STANDARD DEPARTURE CHART-INSTRUMENT

RJFN / NYUTABARU

NIPPO SEVEN DEPARTURE

ILS X or LOC X RWY28

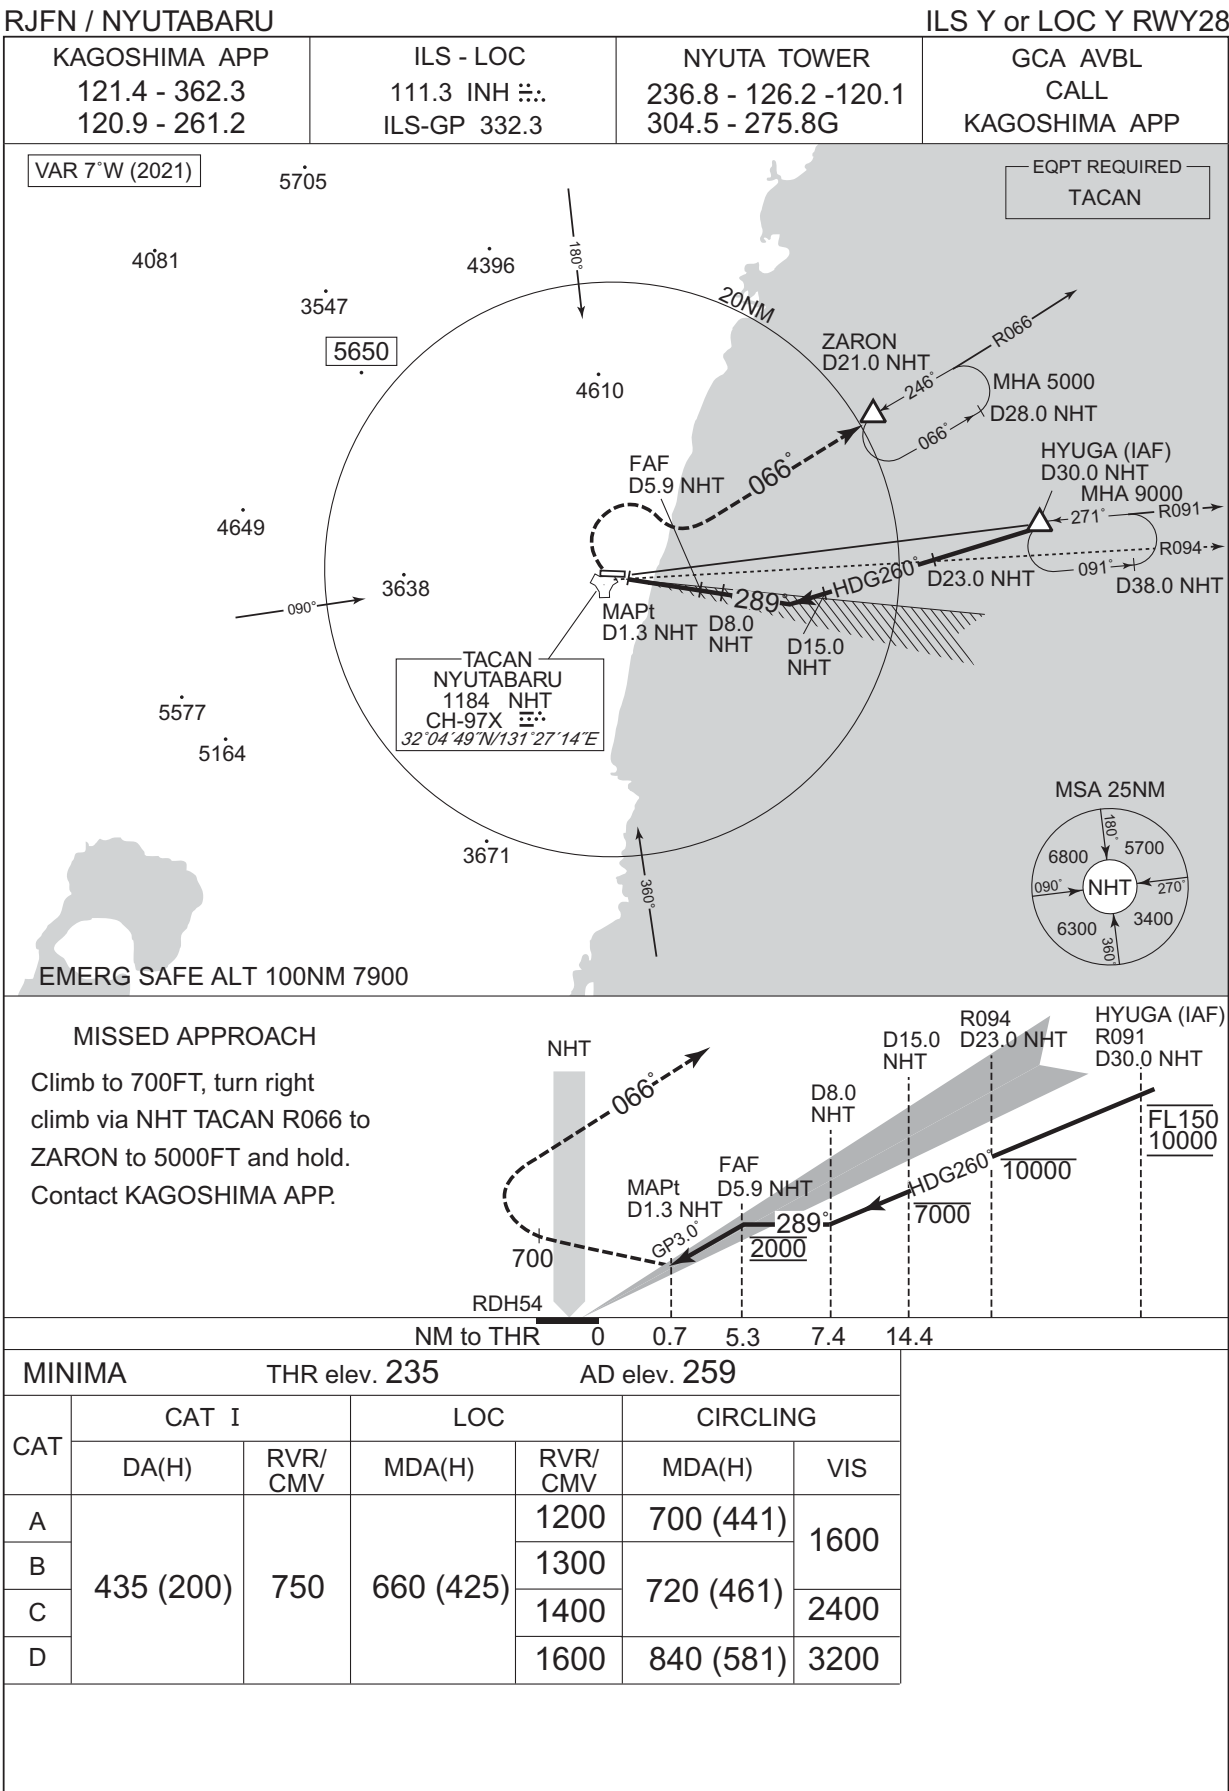
CHANGE : VAR. PROC renamed. EQPT REQUIRED added. PROC course. MISSED APPROACH course. MSA.  
NM to THR added. MDA(H) for CIRCLING.
